RE: **Lot 6 Block 7 Volcano Cliffs Unit 22 SAD 228**  
**6512 Pato Rd. NW**  
**Grading and Drainage Plan**  
**Engineers Stamp Date 3/6/20 (D10D003L6)**  
**Pad Certification Date 3/6/20**

Based upon the information provided in your submittal received 3/9/20, this plan is approved for Building Permit.

ENGINEER'S SEAL  3/6/20 DAVID SOULE P.E. #14522	6512 PATO ROAD	DRAWN BY: WCVJ
	GRADING AND DRAINAGE PLAN	DATE: 3-08-20
	 1606 CENTRAL AVENUE SE SUITE 201 ALBUQUERQUE, NM 87106 (505) 872-0998	2102020-LAYOUT-3-08-20 SHEET # JOB # 2102020

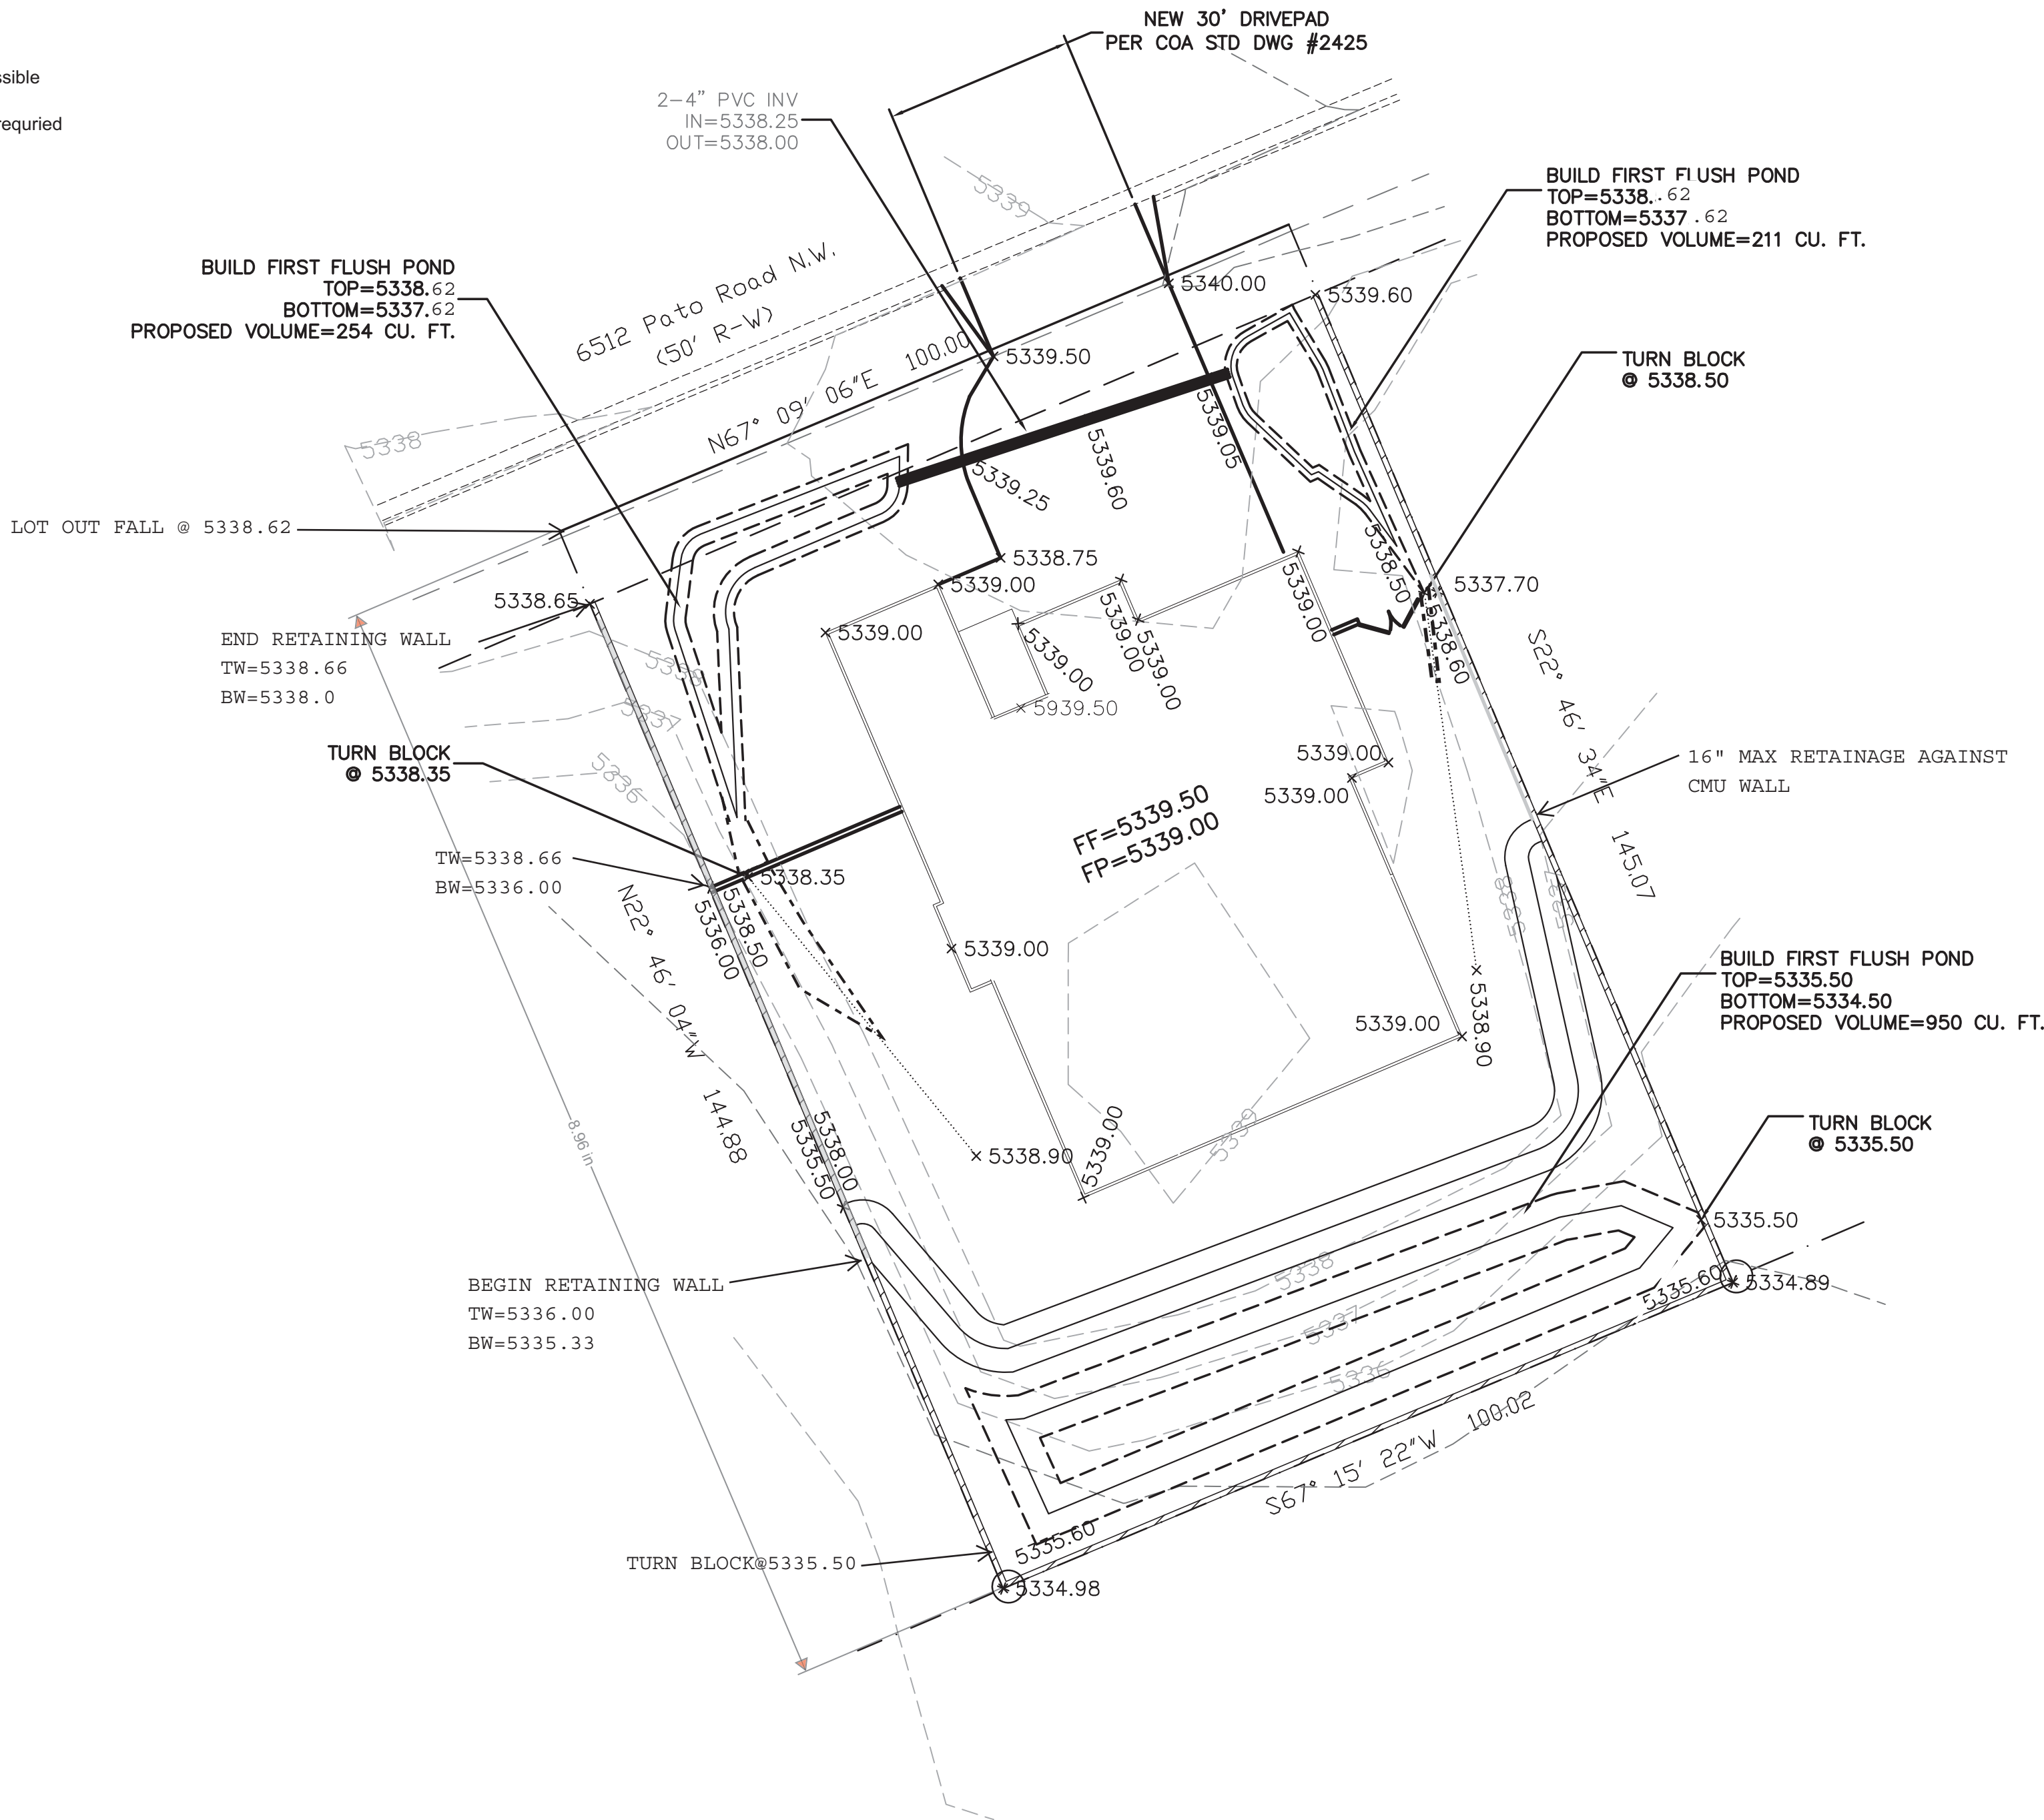
**Reiterate to the Owner/Contractor that a separate permit for a garden/retaining wall must be obtained, with the approved G&D plan dated 3/6/20 and Pad Certification Date 3/6/20.**

Prior to Certificate of Occupancy release, Engineer Certification per the DPM checklist of this plan will be required.
